POINT BEACH NUCLEAR PLANT, UNIT NO. 1

AMENDMENT TO FACILITY OPERATING LICENSE

Amendment No. 168
License No. DPR-24

ATTACHMENT TO LICENSE AMENDMENT NOS. 168 AND 172
TO FACILITY OPERATING LICENSE NOS. DPR-24 AND DPR-27
DOCKET NOS. 50-266 AND 50-301

Figure 15.3.1-1/PBNP Units 1 & 2
Heatup Limitations Applicable to
23.6 Effective Full Power Years
(Approximately January 2001)

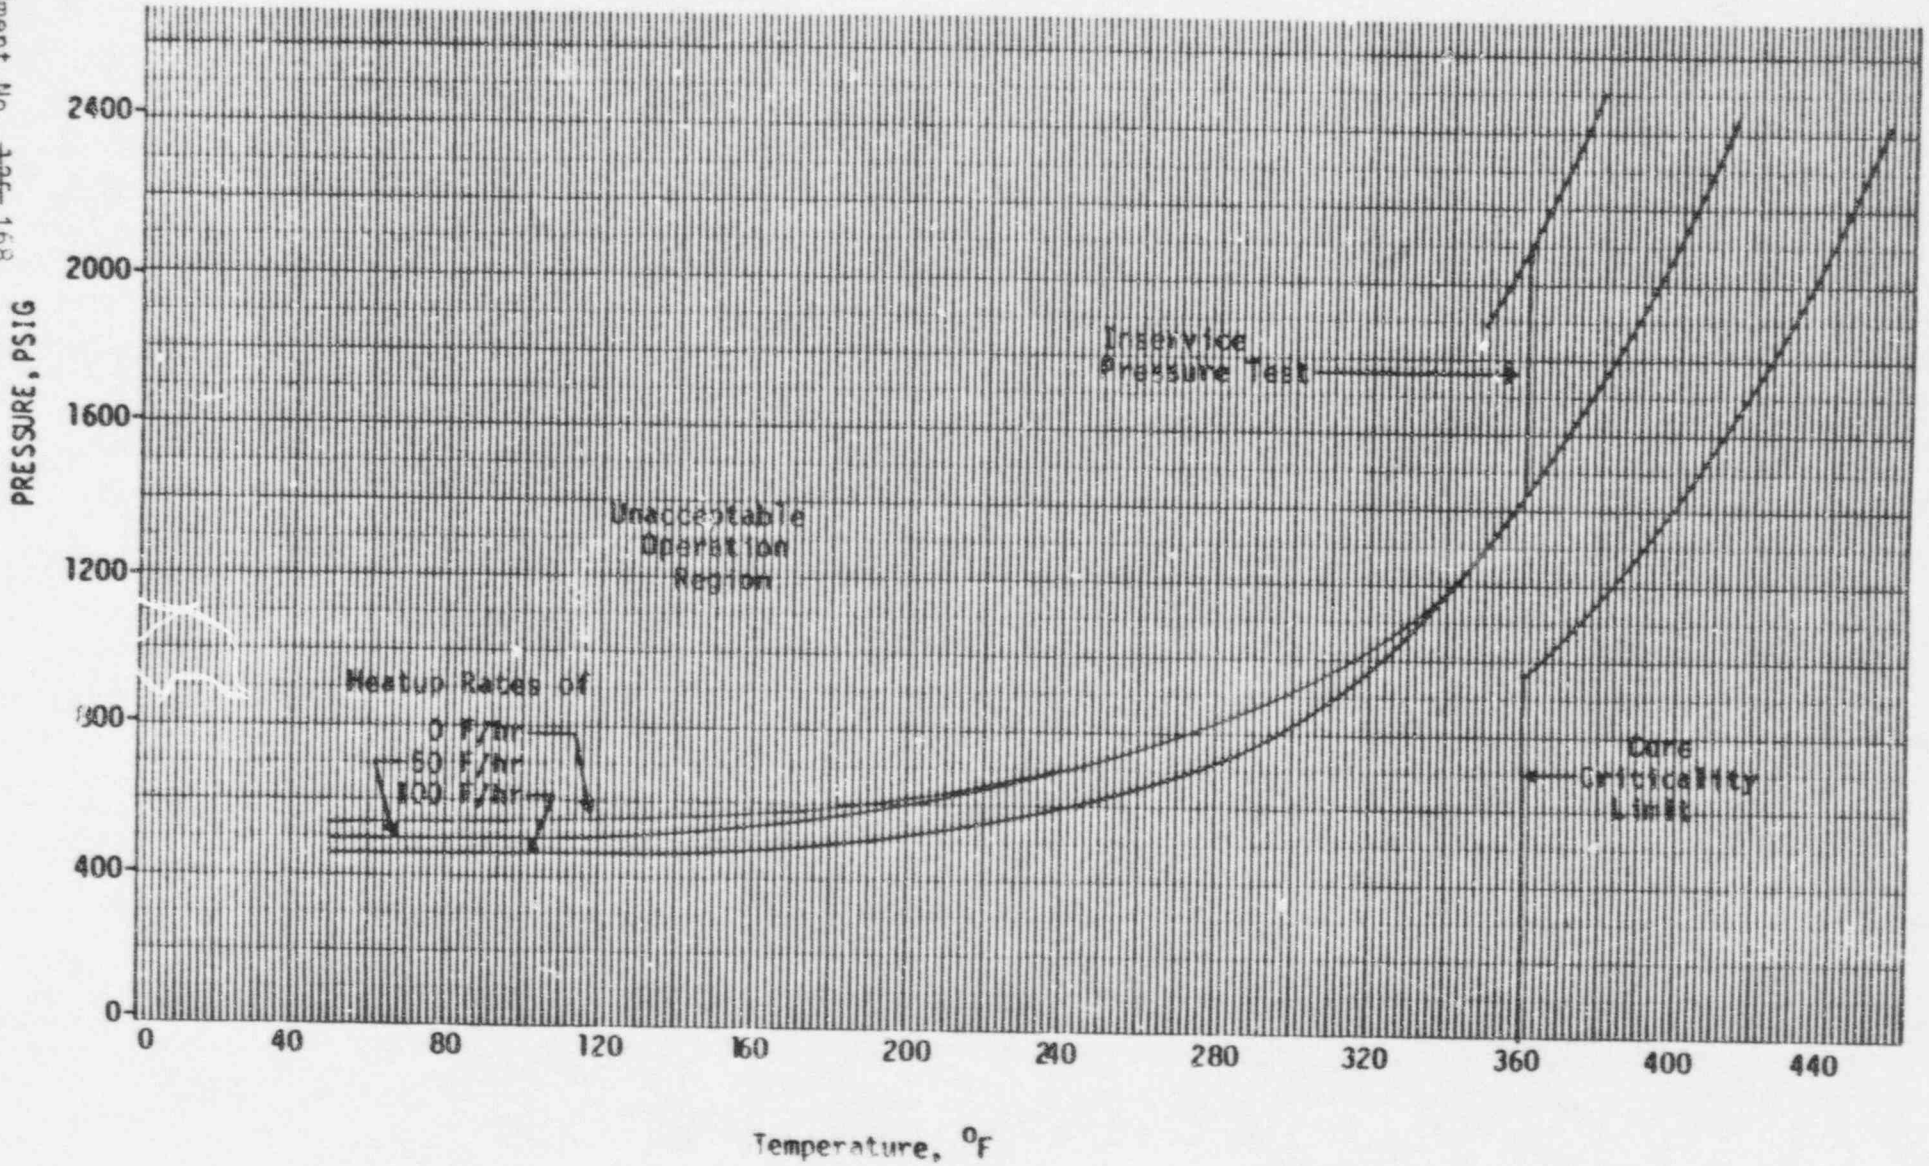
The heatup and cooldown curves presented in Figure 15.3.1-1 and 15.3.1-2 were calculated based on the above information and the methods of ASME Code Section III (1974 Edition), Appendix G, "Protection Against Nonductile Failure", and are applicable up to the operational exposure indicated on the figures.

The pressure-temperature limit lines shown on Figure 15.3.1-1 for reactor criticality and for inservice leak and hydrostatic testing have been provided to assure compliance with the minimum temperature requirements of Appendix G to 10 CFR 50 for reactor criticality and for inservice leak and hydrostatic testing.
